REVISION 001 TO A INVITATION TO TENDER

Title - Sujet : Mechanical Systems Upgrade, Battle of the Restigouche National Historic Site		
Solicitation No. - N° de l'invitation : 5P468-21-0158/A	Date : 08 December 2021	
Amendment No. - N° de modification : 001		
Client Reference No. - N° de référence du client : 1408		
GETS Reference No. N° de référence de SEAG : PW-21-00975348		
Solicitation Closes - L'invitation prend fin : At - à : 14 :00 On - le : 16 December 2021		Time Zone - Fuseau horaire EST
F.O.B. - F.A.B. : Plant - Usine : <input type="checkbox"/> Destination : <input checked="" type="checkbox"/> Other - Autre : <input type="checkbox"/>		
Address Enquiries to - Adresser toutes demande de renseignements à : Jaime Creaser		
Telephone No. - N° de telephone : 902-266-8592	Fax No. -N° de télécopieur : 1-877-558-2349	Email Address – Courriel : Jaime.Creaser@pc.gc.ca
Destination of Goods, Services, and Construction - Destination des biens, services, et construction : See Herein

File : Mechanical Systems Upgrade
APC Project : 1408-4

Addendum No : ME-01

IDENTIFICATIONS (TEMPORAIRE ET CONSTRUCTION) / KEYNOTES (TEMPORARY AND CONSTRUCTION)

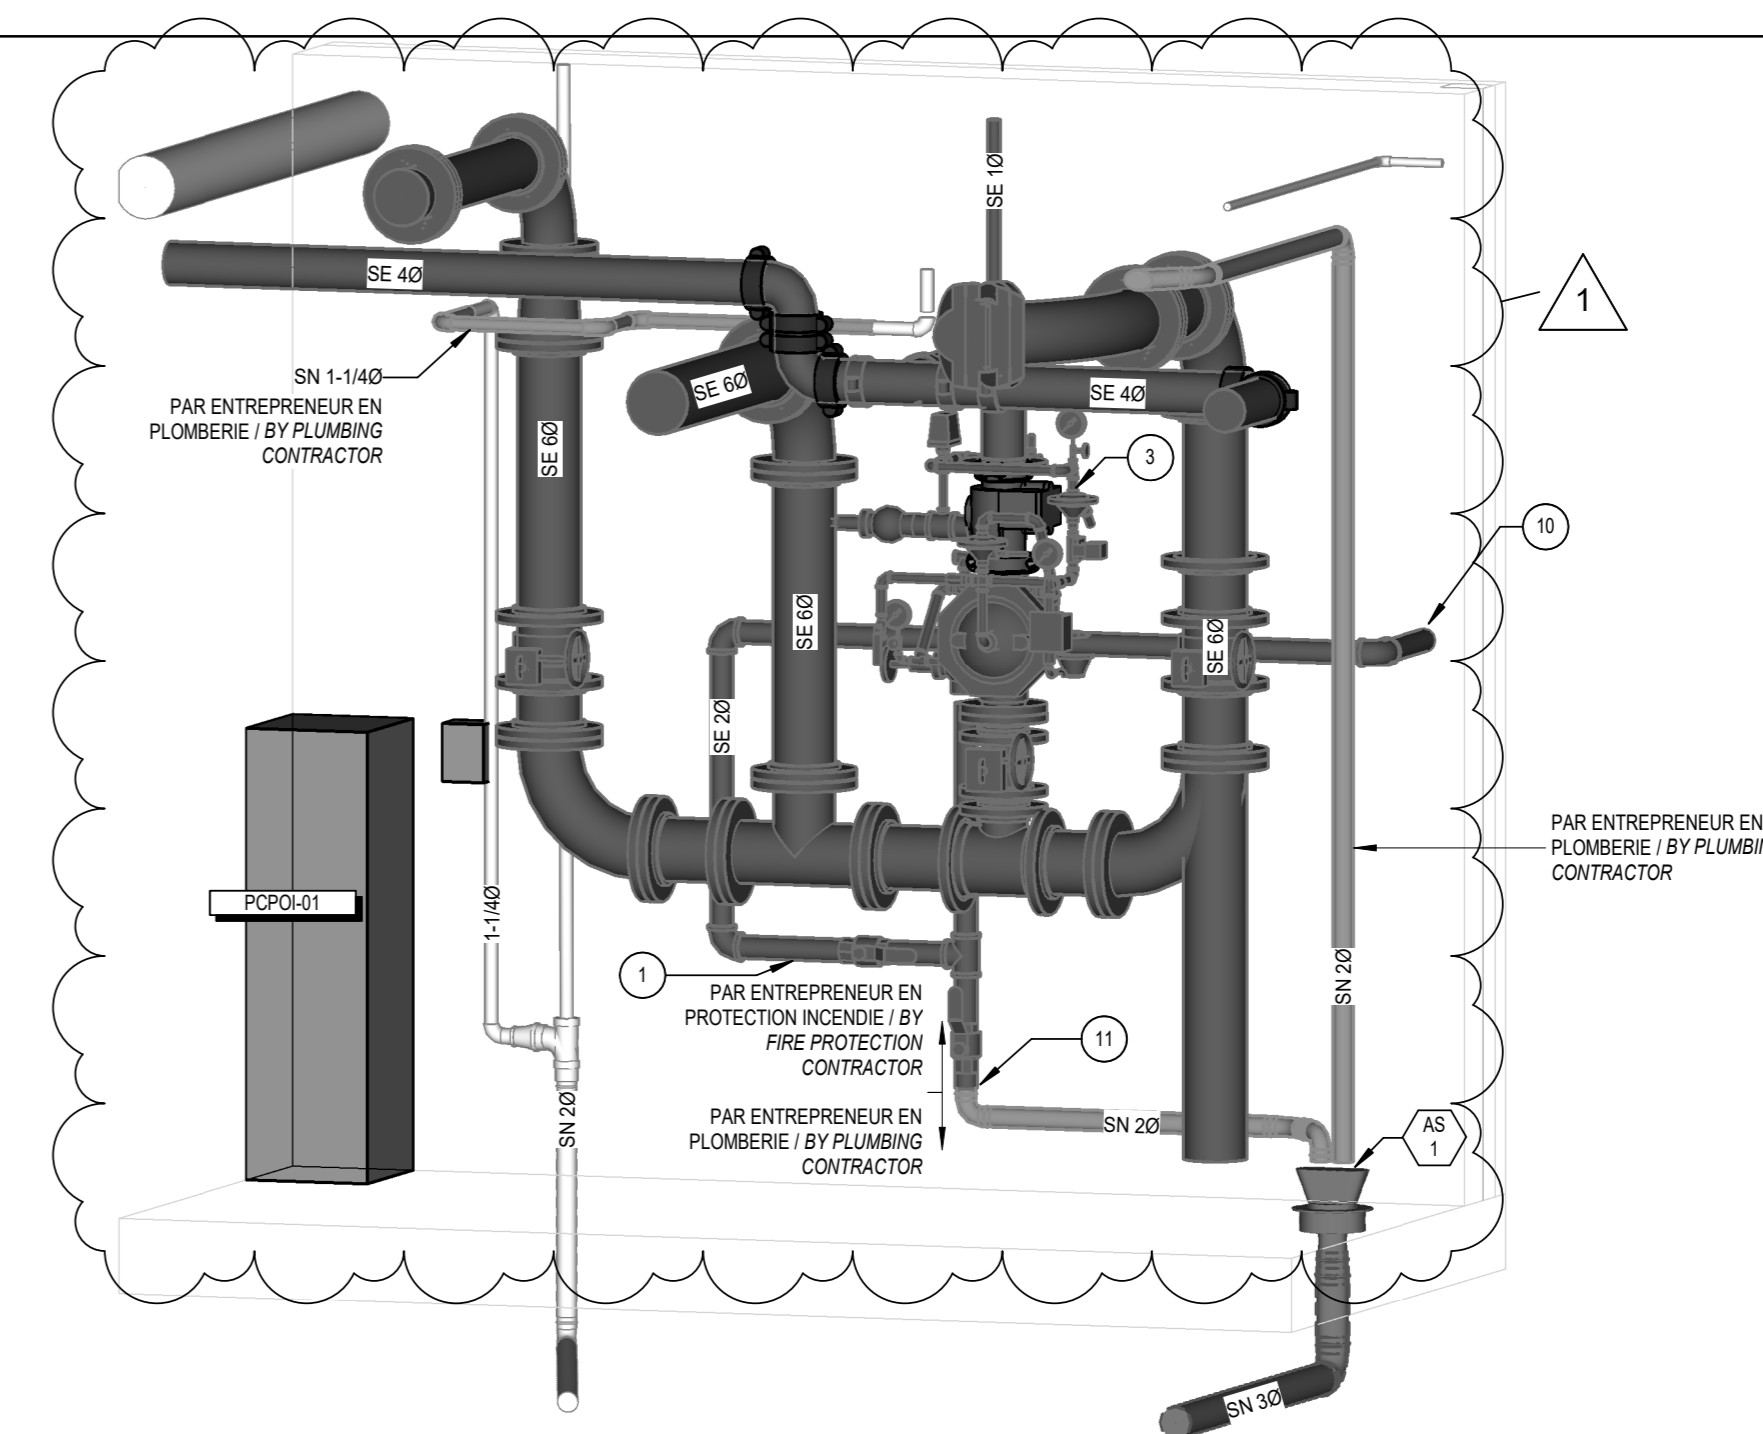
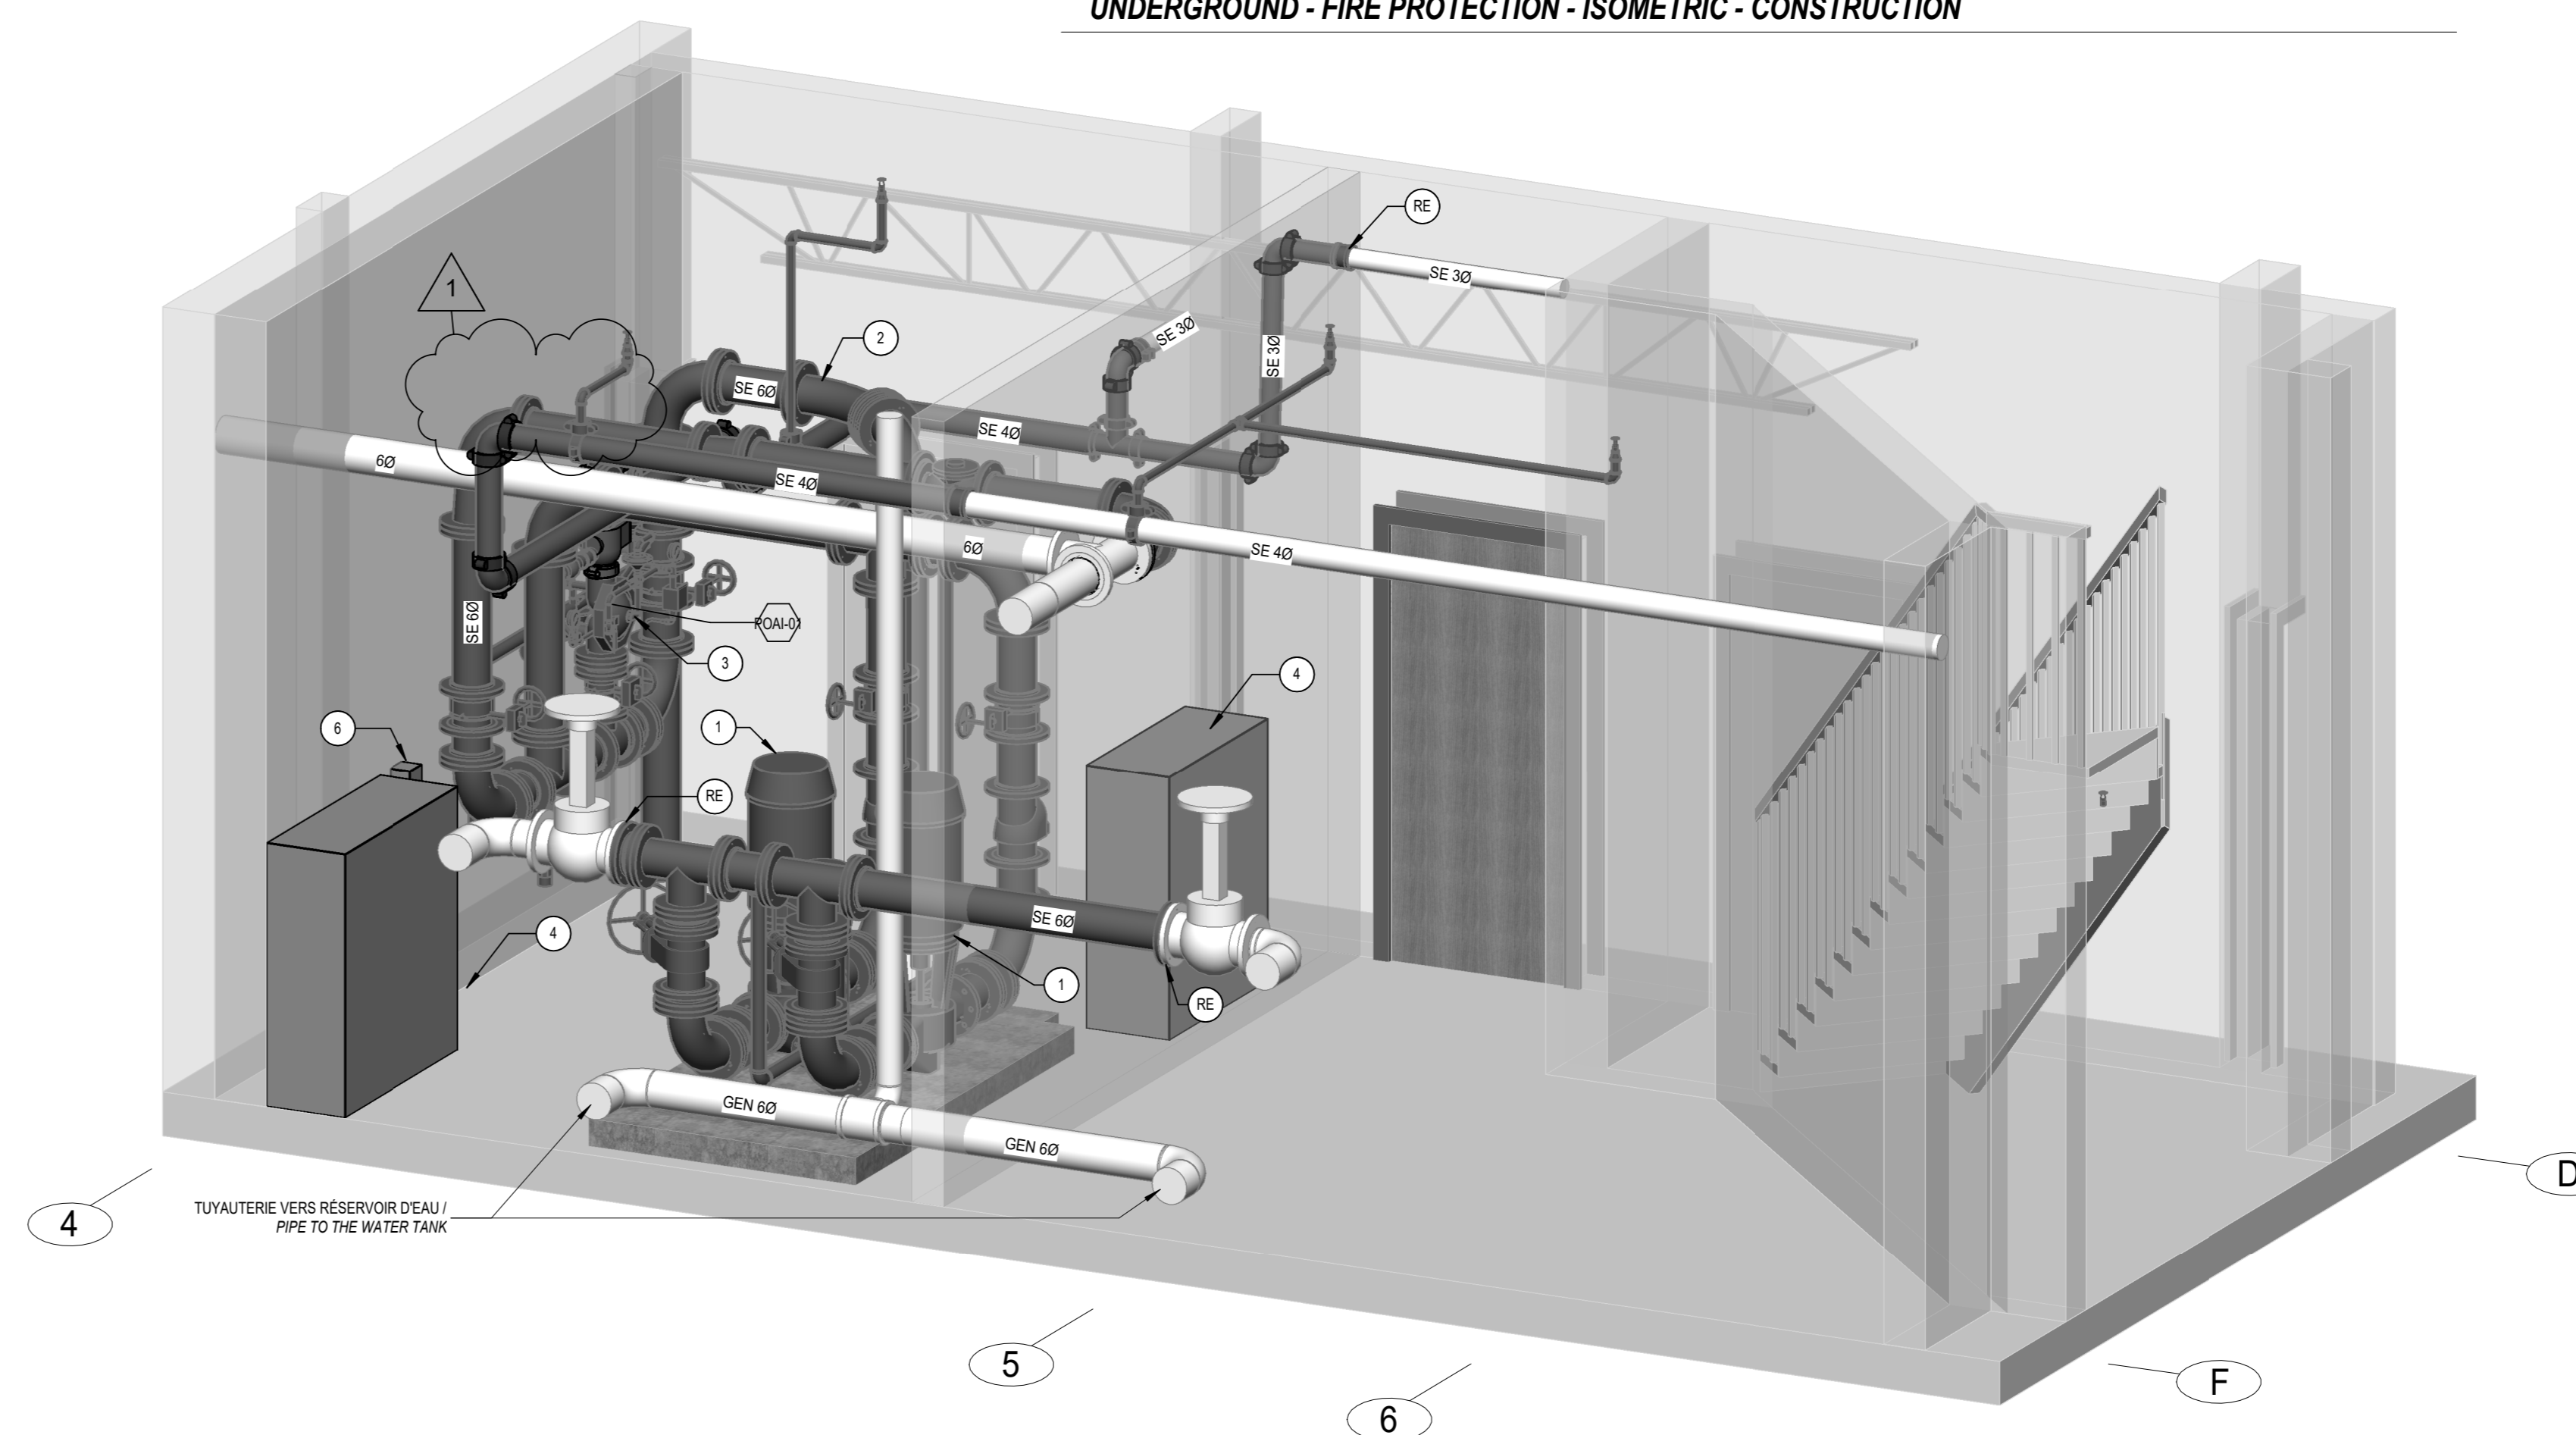
2.1.2 Plan M302 - FIRE PROTECTION - UNDERGROUND FLR - CONSTRUCTION

.1 The existing water motor gong is dismantled and not to be connected to the new alarm valve. Keynotes #7 and #9 are cancelled.

.2 Plan M302 is reissued with revision 1.
